U.S. DEPARTMENT OF TRANSPORTATION
FEDERAL HIGHWAY ADMINISTRATION
EASTERN FEDERAL LANDS HIGHWAY DIVISION

Amendment No. 001
Rock Creek and Potomac Parkway
Project ROCR 3A5, 204(1)
DTFH71-07-B-00008

The purpose of this Amendment is to:

ROCK CREEK & POTOMAC PARKWAY
 STA. 6+50 TO STA. 11+00
 LIGHTING PLAN

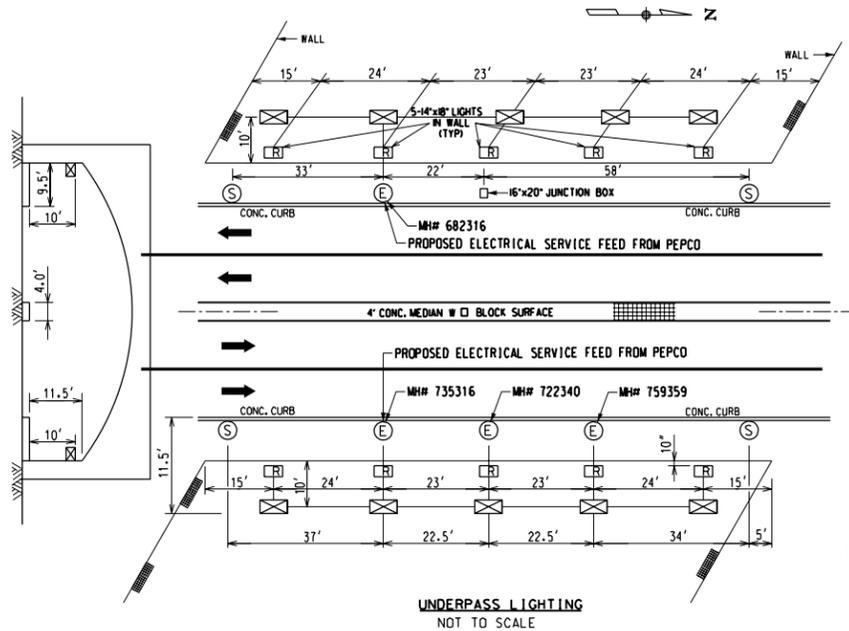
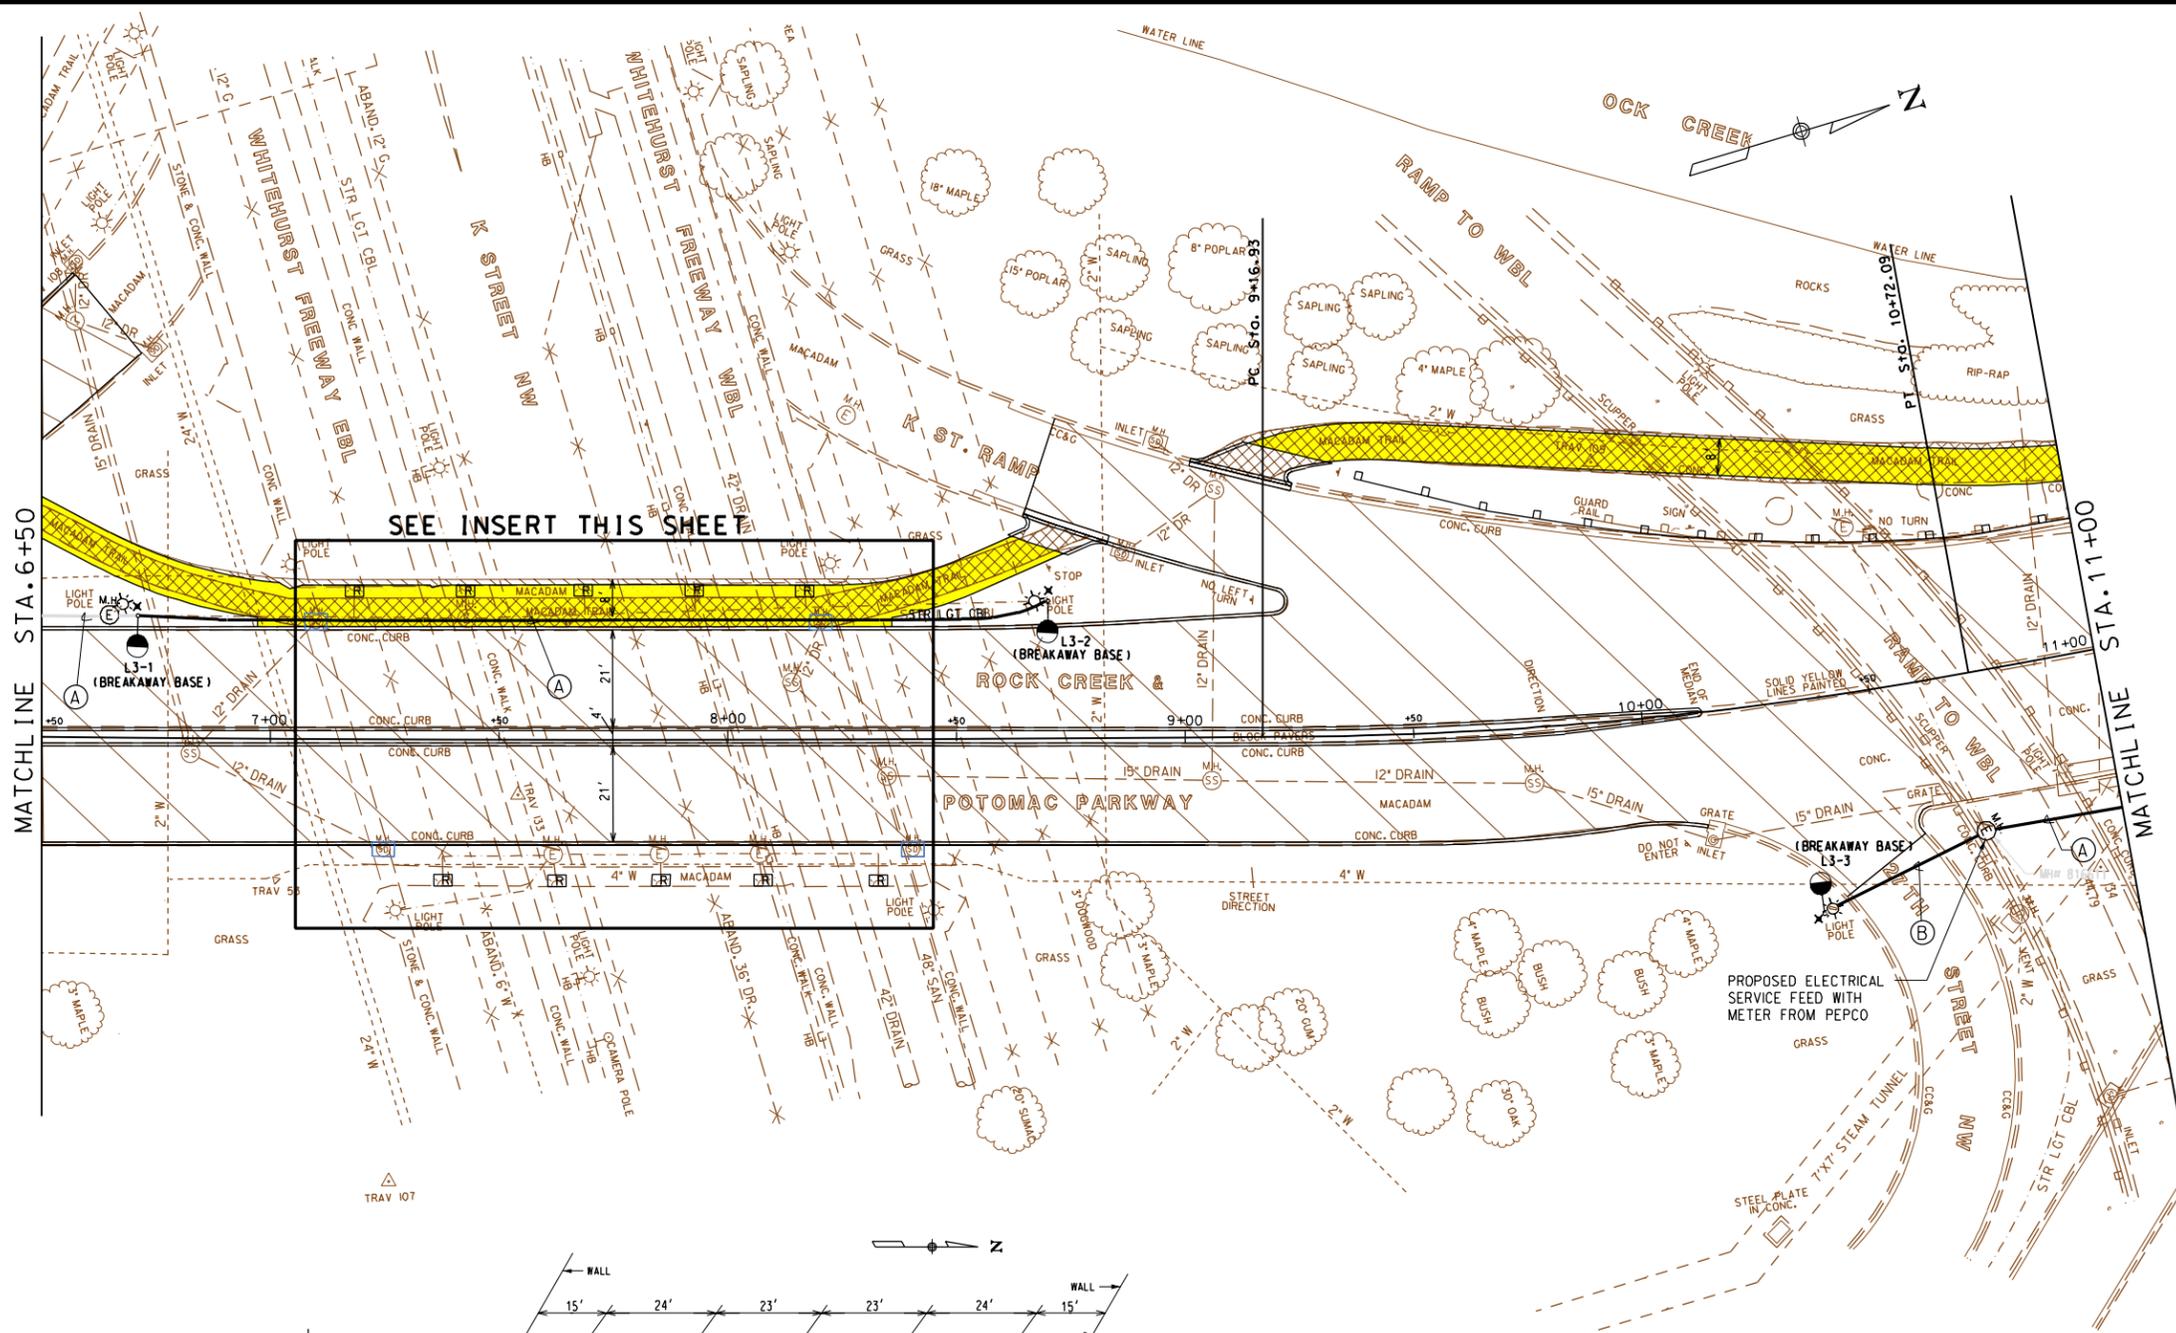
- 1) Revise the Special Contract Requirements (Subsection 413.04 and 413.05) to delete pay item 41301F, "Asphalt pavement milling, 2 inch depth".
- 2) Revise plan sheet 138, Detail E636-C, to change 3/4" diameter bolts to 3/8" diameter stainless steel bolts and specify the wall plate shall be ASTM A 666, Type 304 stainless steel.
- 3) Replace plan sheet 12, Summary of Quantities and revise the B pages, B-9 through B-12, for the deletion of Pay Item 63606GB, Conduit, 2-Inch Rigid Galvanized Steel (bored).
- 4) Revise plan sheet 86 to correct utility symbology.
- 5) Replace 8 plan sheets for legibility.
